# MANDATORY SERVICE BULLETIN

## NO. MSB-42-039

Installation of a redesigned breather line and a new oil separator

### „REDESIGN OF BREATHER LINE AND OIL SEPARATOR “

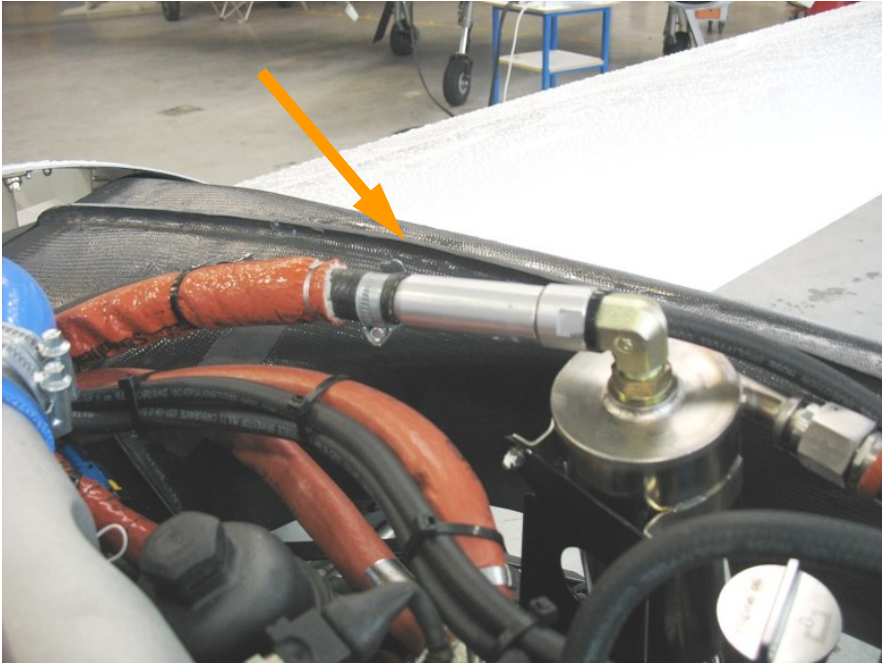
3	<p>Install new oil separator and new breather line according the following picture of this WI. Shorten breather line and fire sleeve as required and install breather line bypass (D60-7906-40-30 / D60-7906-40-31) acc. to picture.</p> 
4	Clean working area, check for foreign objects.
5	Check new installed items and all systems in working area for proper function.
6	Make appropriate entries into aircraft log.
